HI-MILL MANUFACTURING COMPANY
FINAL TECHNICAL MEMORANDUM

Revision #3
Master Copy

June 1991

Below are comments concerning the Hi-Mill Manufacturing Draft Technical Memorandum from Karla Johnson of the USEPA (#1-#10), Murat Akyurek of Donohue & Associates (#11-#21) and Deborah Larson of the MDNR (22-#26). Each comment/concern from the agency is followed by a corresponding response from Geraghty & Miller, Inc.

FIGURE 6
BACKGROUND SOIL,
SOIL & SURFACE WATER SEDIMENT
SAMPLING LOCATIONS
 HIMILL MANUFACTURING
 HIGHLAND MICHIGAN

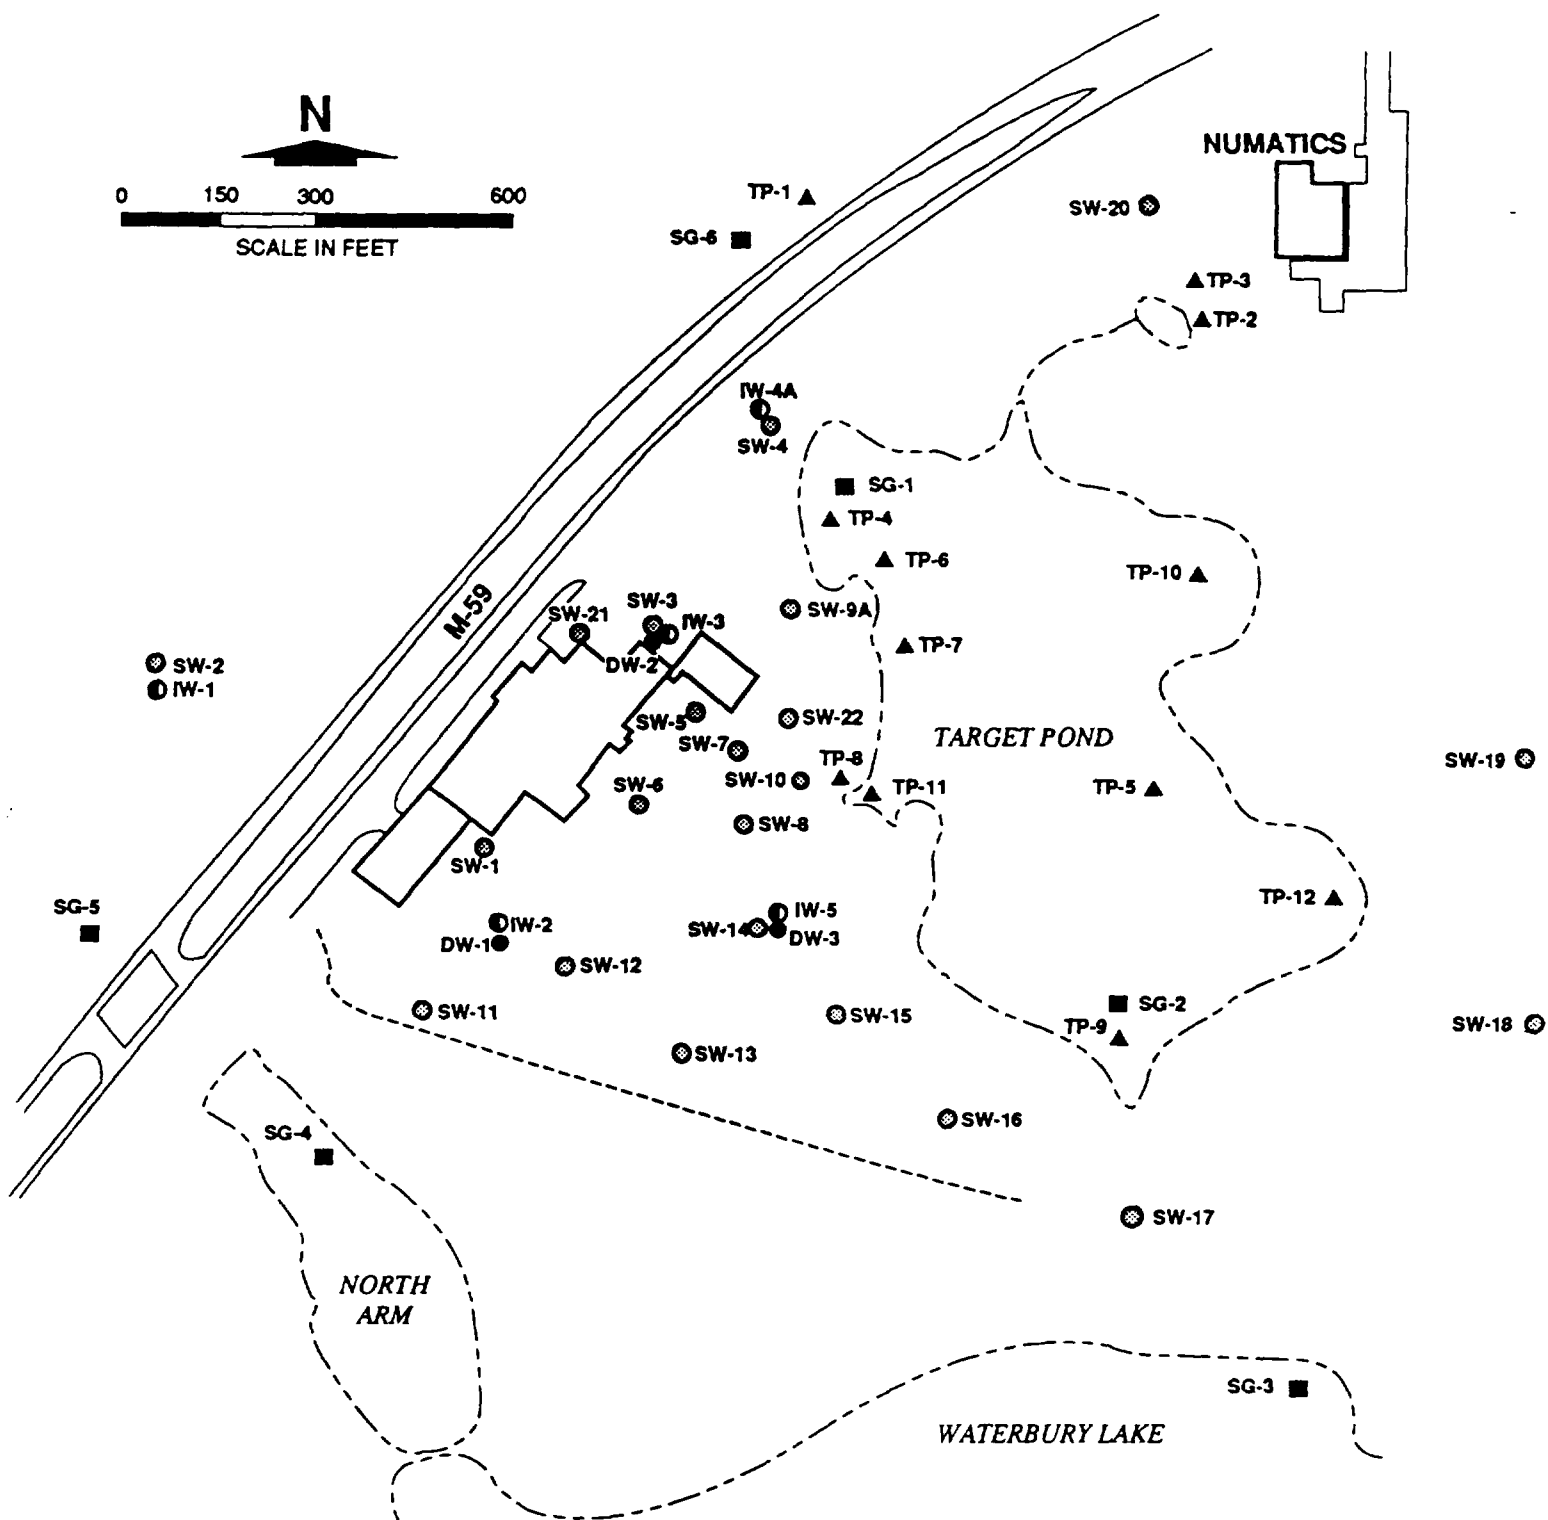
6a	10/3	C: Where were the background soil samples taken? R: Figure 6 shows the collection point for each of the 6 background soil samples. Table 3 identifies the 10 samples collected from the 6 different locations and the 7 samples that were used in the statistical analysis.

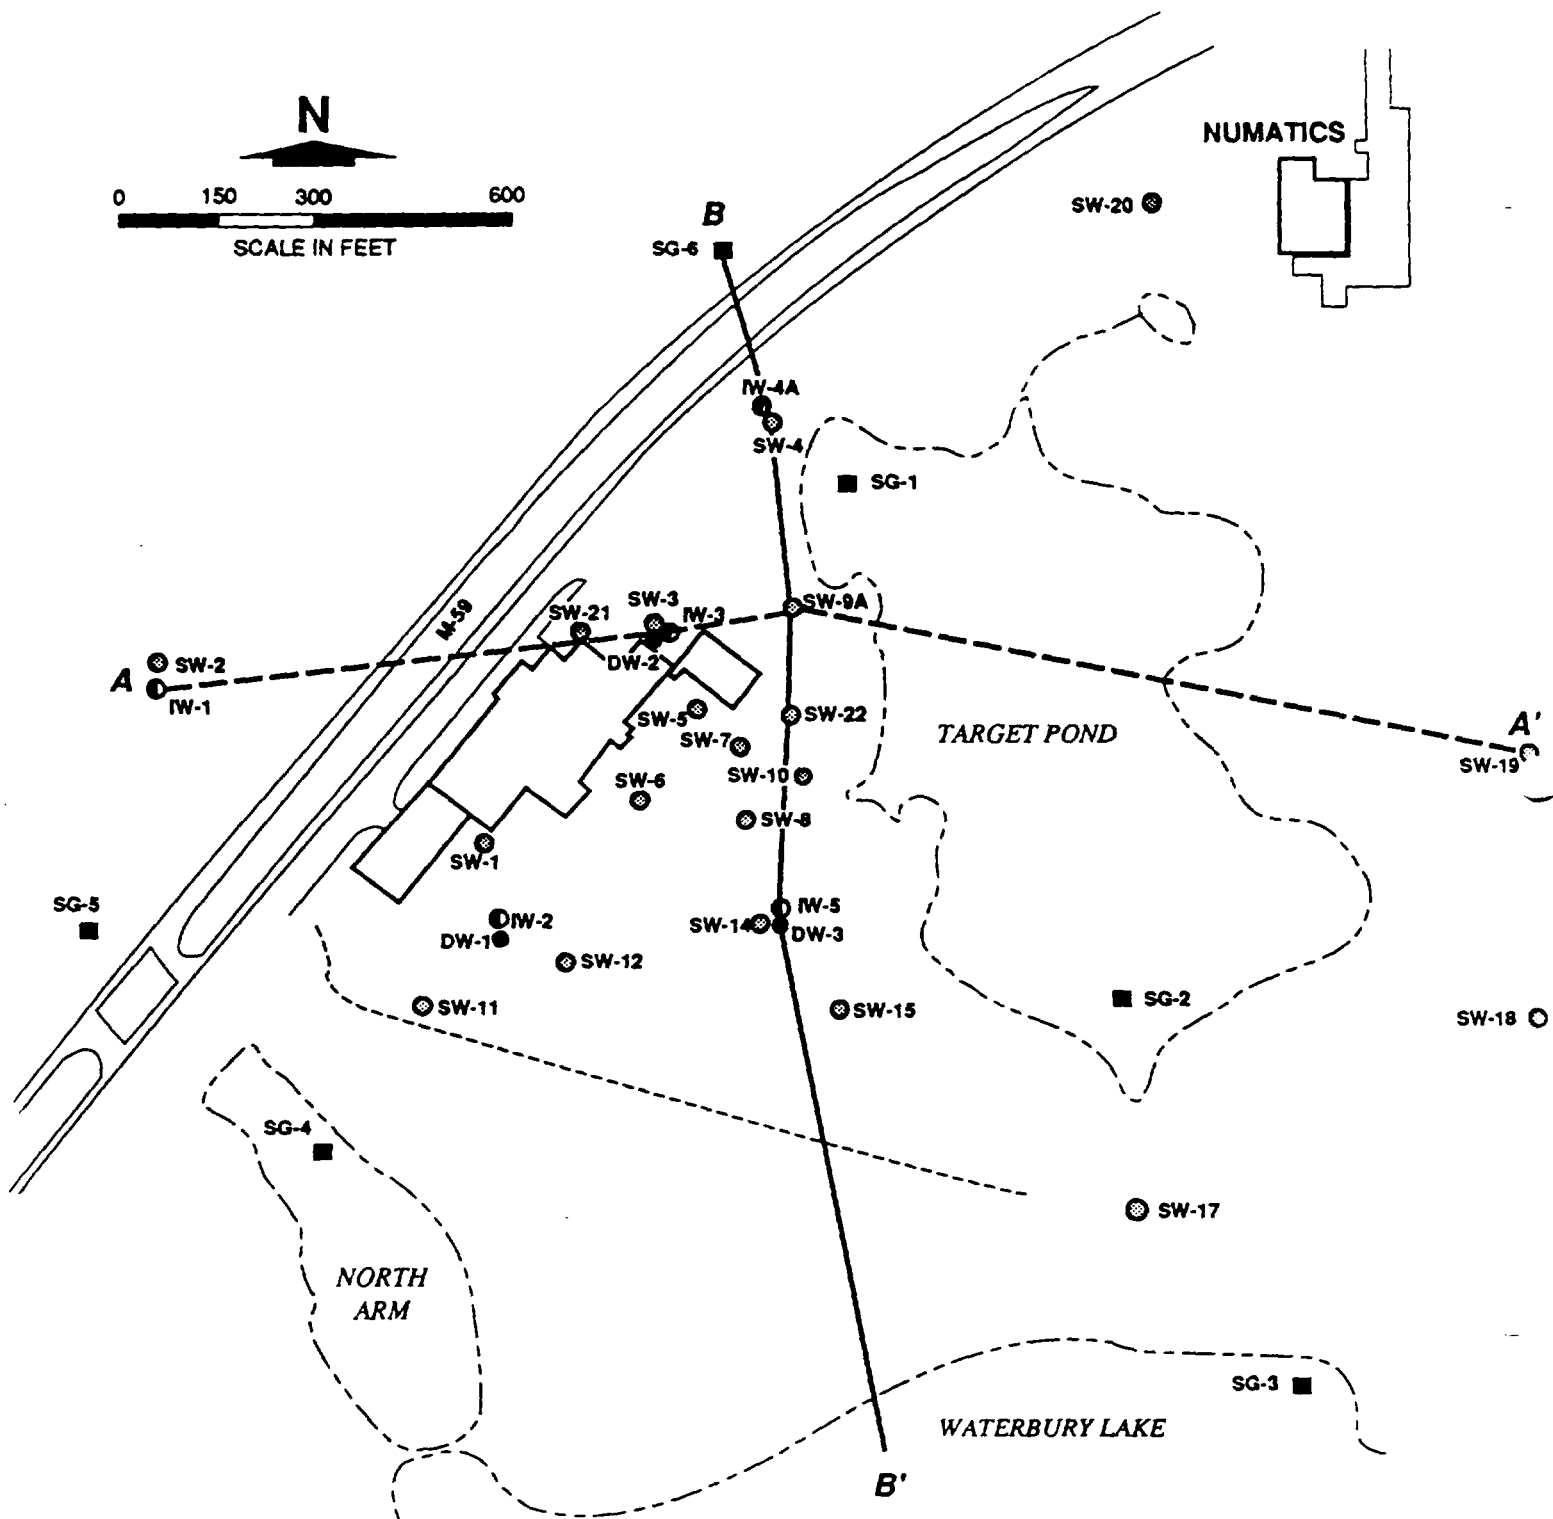
#	page/paragraph	comment/response
1	2/2	C: Figure 7 shows 28 monitoring wells not 27 as stated in the text. R: Typographical error, revised text to read "28" wells.
2	2/6	C: The legend for Figure 10 misrepresents the brown clay layer. R: Revised the legend in Figure 10 to read correctly.
3	3/5	C: In the first sentence, Hydrogeologic Unit VI should be Hydrogeologic Unit VII. R: Typographical error, revised text to read "outwash sands" of Hydrogeologic Unit VI (not the "blue clay" of Hydrogeologic Unit VI)".
4	8/1	C: Figure 1 does not show that the topography west of the plant slopes toward the North Arm of Waterbury Lake, as stated. R: Typographical error, Plate I of the Technical Memorandum shows the westward slope of the topography .
5	10/2	C: Please place Tables 2A-2E and Tables 4A-4D in alphabetical order in the back of Part 1. R: Compilation error, Tables 2A-2E will be in alphabetical order in final report.

- 9c 11/3 C: There are 28 wells shown on Figure 7 not 27 as stated.
R: Typographical error, the text has been revised to reflect 28 wells.
- 9d 11/3 C: Why isn't SW-13 shown on Figure 7?
R: Monitoring wells SW-13 and SW-16 were dry holes. However they are now both plotted on Figure 7 for future reference.

FIGURE 13
HYDRAULIC CONNECTION
BETWEEN TARGET POND
AND WATERBURY LAKE
JUNE 8, 1990
HIMILL MANUFACTURING
HIGHLAND MICHIGAN

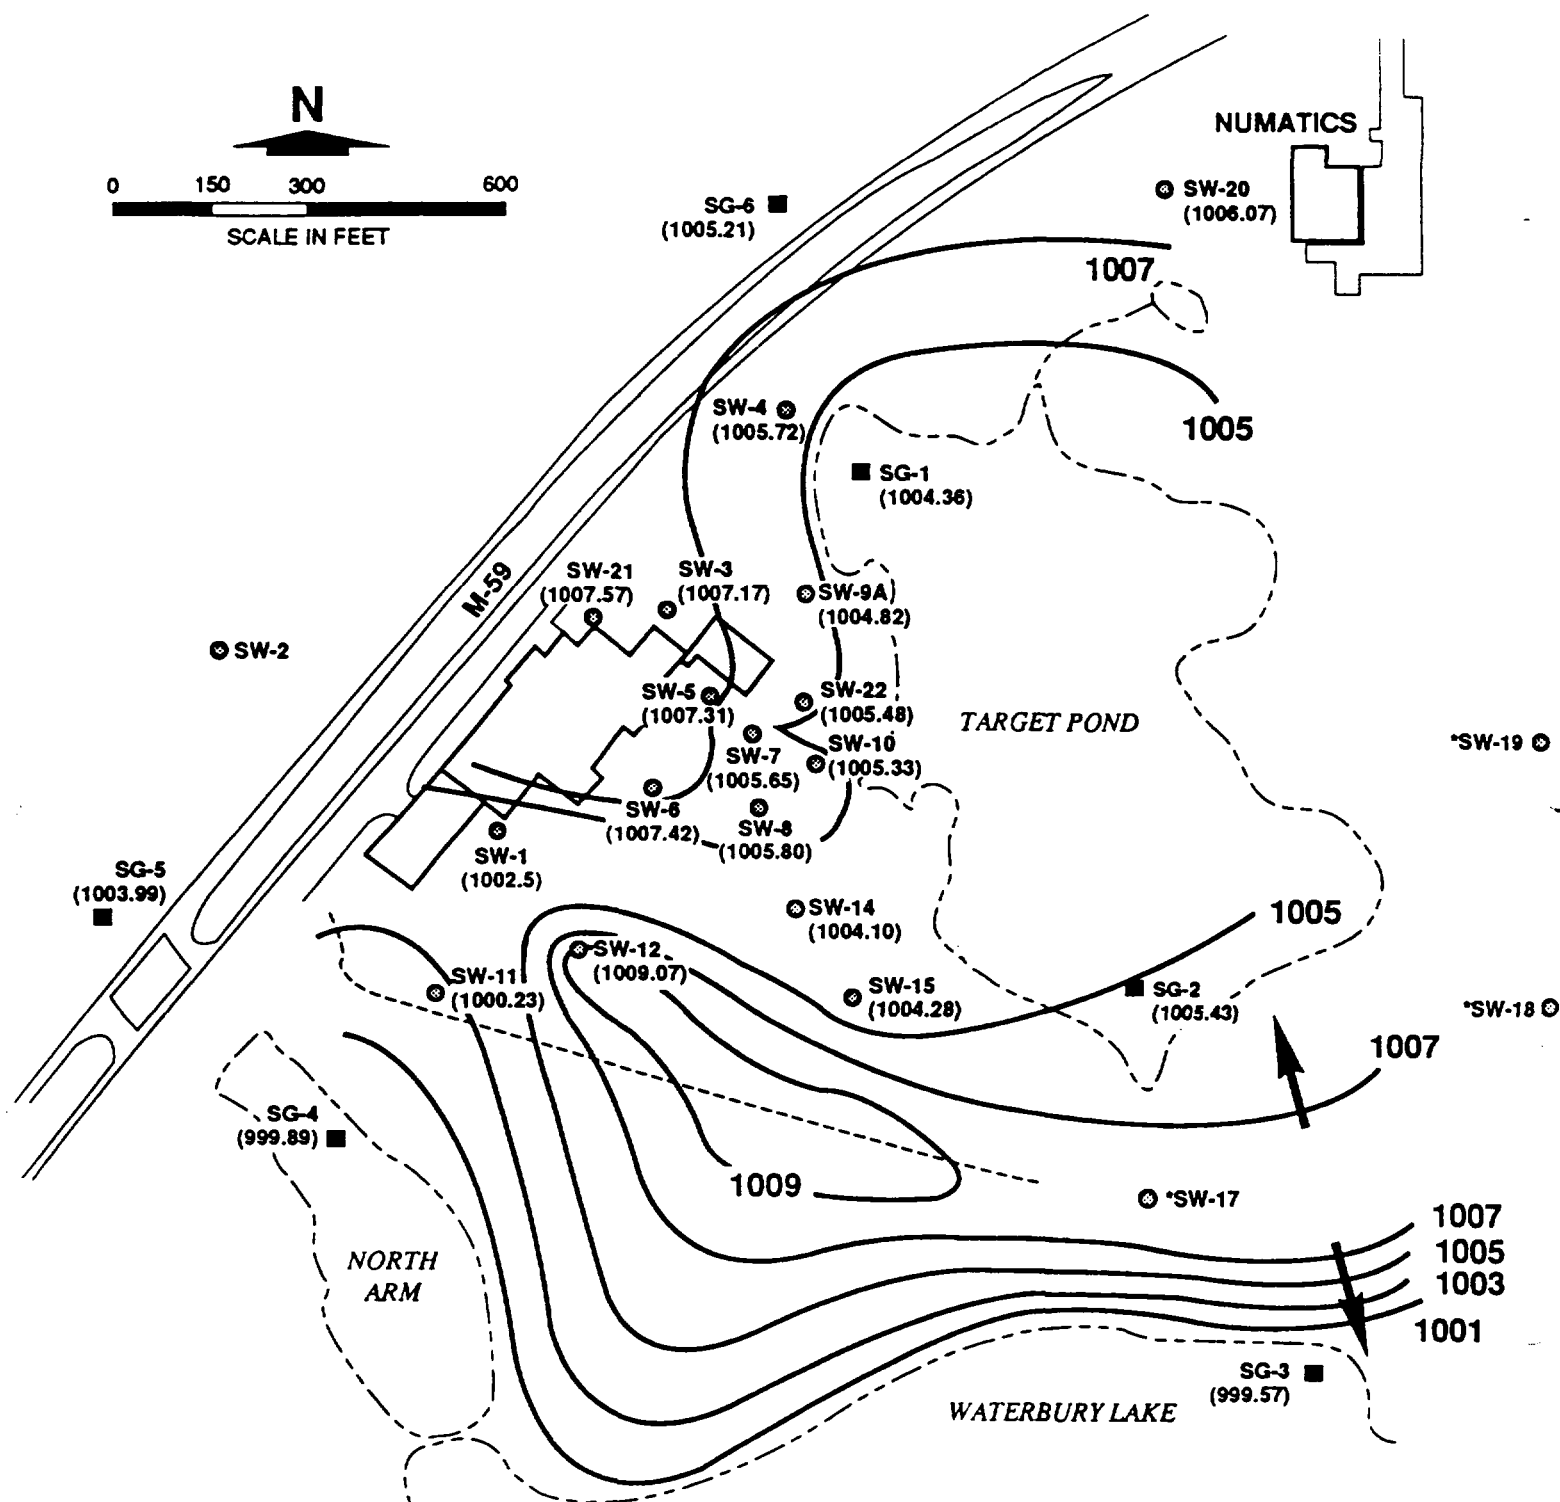
13b 4/4 C: Figure 13 does not show a contour configuration suggesting ground-water flow from the 1,004-foot elevation in the pond to the 999.57-foot elevation in Waterbury Lake. These two elevations are not labeled on the figure. It is also unclear if SW-12, SW-15, and SG-2 were incorporated into Figure 13. If not, there appears to be limited basis for closing the 1,009-, 1,007- and 1,005-foot elevation contours. This representation suggests a mounding, with limited flow from Target Pond to Waterbury Lake.

13d 4/5 C: Please correctly label the equipotential line within the legends of Figure 13 and 14. It is also suggested that these figure titles reflect consistency.

R: Ground-water elevations and arrows representing ground water flow direction were added to Figure 13.

R: The legend description was corrected on both Figure 13 and 14. The title of Figure 14 changed to reflect consistency.

FIGURE 15
SHALLOW WELLS
POTENTIOMETRIC SURFACE
OCTOBER 31, 1990
HIMILL MANUFACTURING
HIGHLAND MICHIGAN

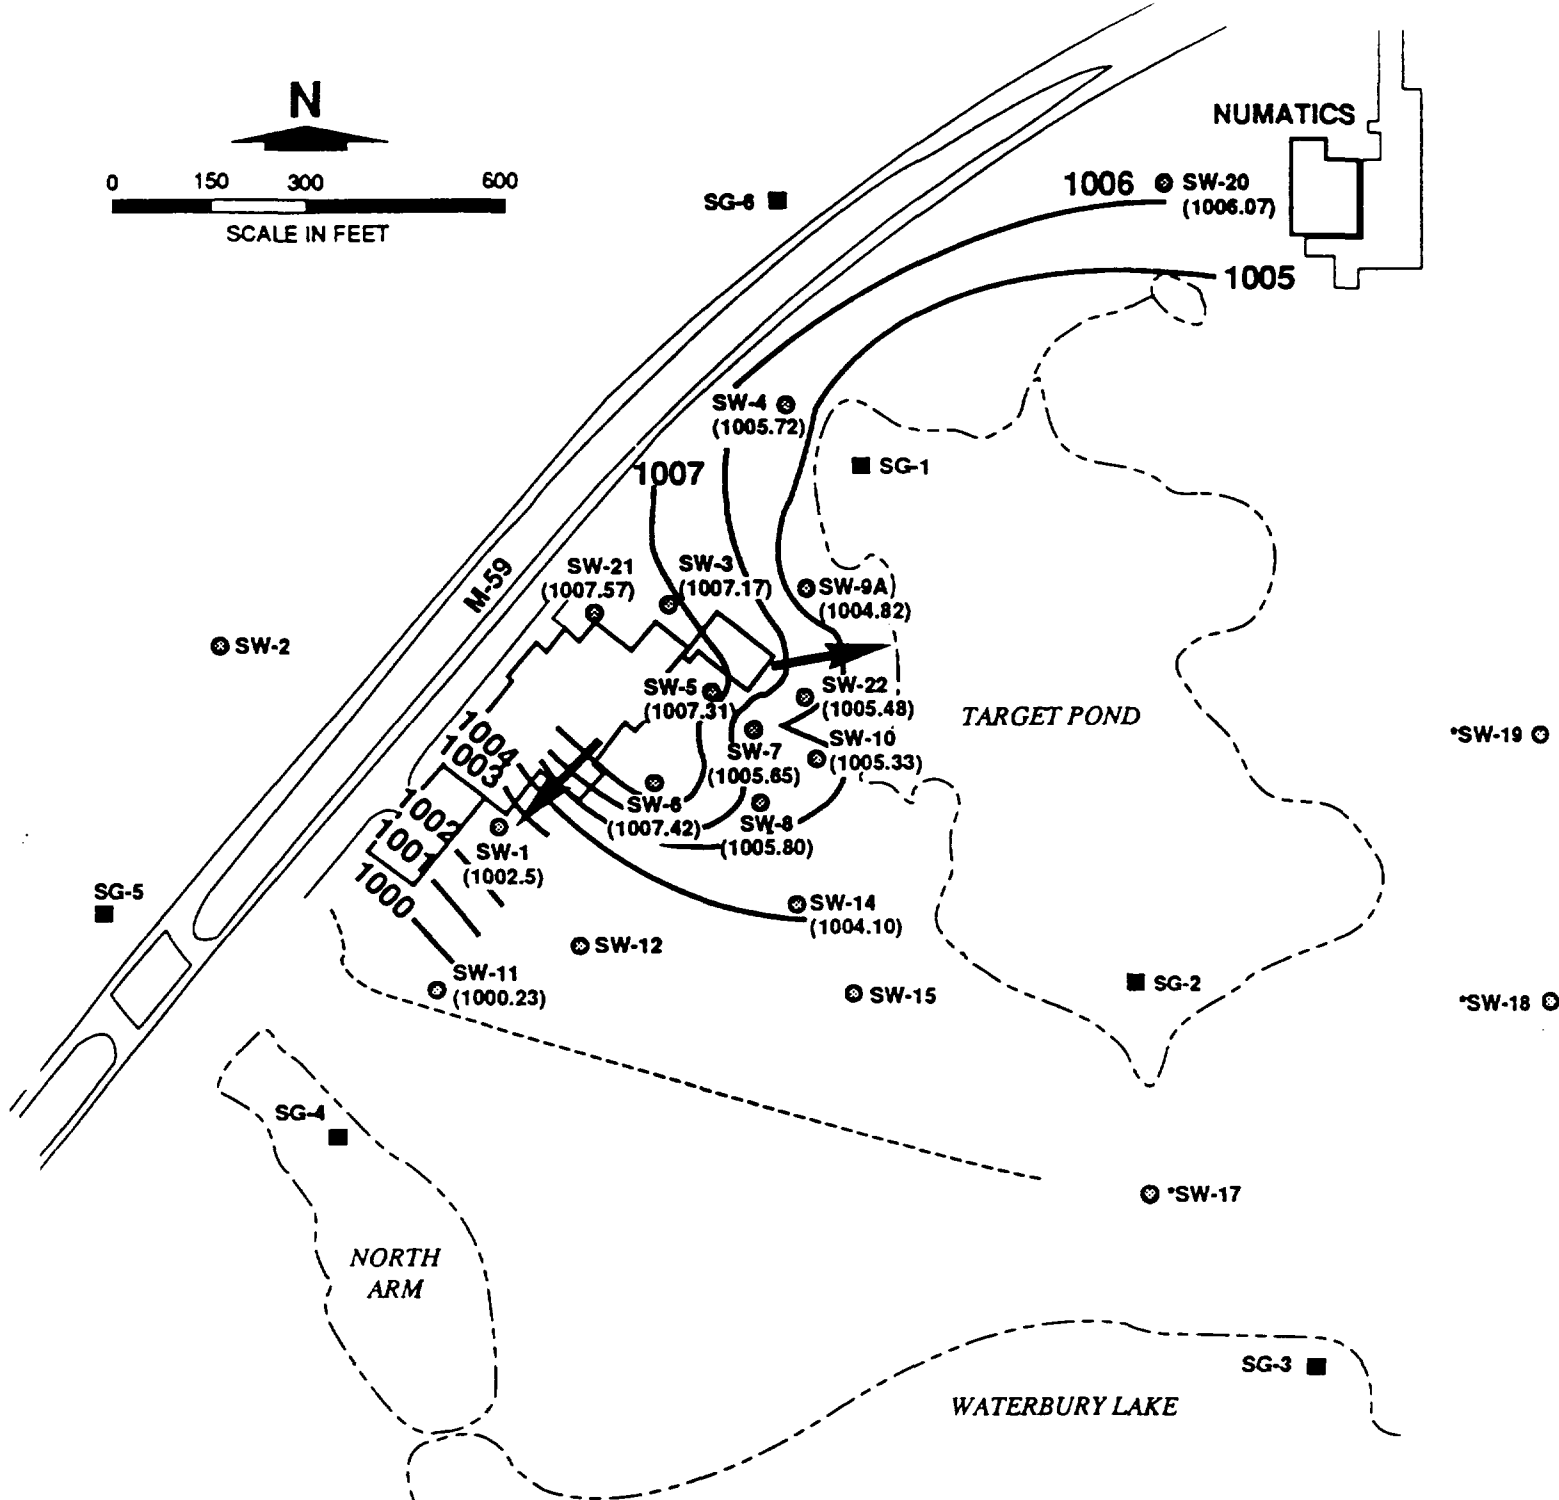
- R: Typographical error, the appropriate corrections have been made in text.
- 17b 7/2 C: The staff gauge elevations are not represented on the potentiometric map of the perched system (Figure 15). Also, ground-water flow direction arrows should be added to the figure.

- 20 8/2 C: This paragraph now introduces a preferential northwest flow direction. Based on preceding paragraphs, this now includes every direction. Please be specific, limit conclusions to data examined, and clarify this discussion. As drawn, Figure 15 does not suggest a northwest flow direction.

- R: Ground-water flow arrows were added. Staff gauge elevations were not.
- 18 7/3 C: Plate I does not appear to be included.
- R: Compilation error, Plate I has been reproduced and is included in the report.

- R: Typographical error, the correction in the text now indicates a preferential "southwest" flow is possible. Figure 15 supports this interpretation.

FIGURE 16
WELL SCREEN ELEVATIONS
SHALLOW WELLS
HIMILL MANUFACTURING
HIGHLAND, MICHIGAN

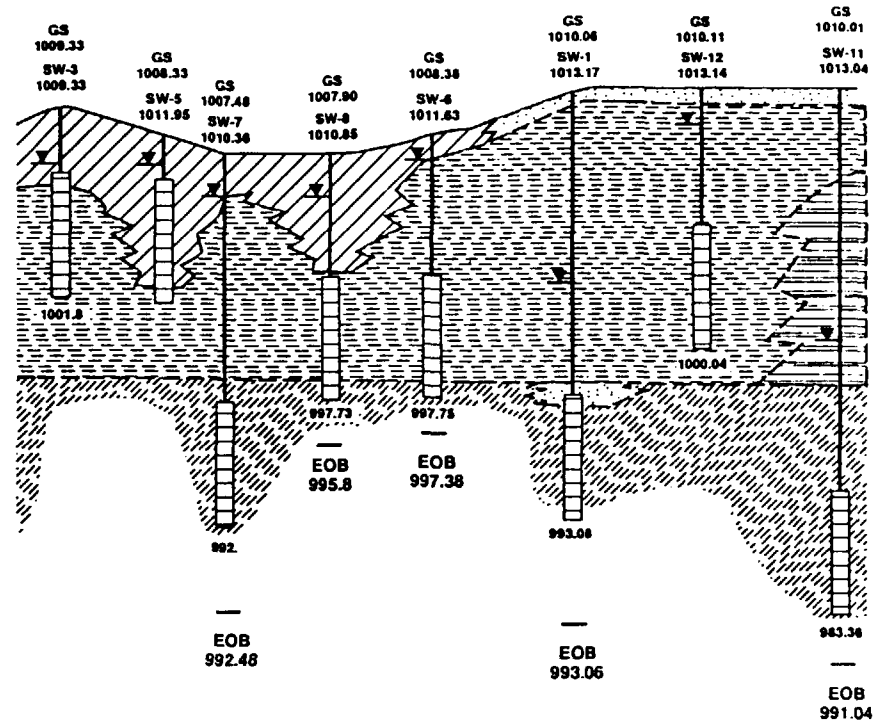
- R: Possibly, additional field work will determine if that is the case.
- 16 6 C: This discussion is very good. It has important implications to the interpretation of shallow ground-water flow direction, and subsequently, to contaminant movement within the shallow ground-water system. Reference to Figure 16 should be added. Line of cross-section for Figure 16 should be shown.

- R: A reference to Figure 16 was made in the text.
- 17a 7/2 C: Ground water elevations ranged from a high of 1007.57 and 1000.23 rather than 107.57 and 100.25 as stated.
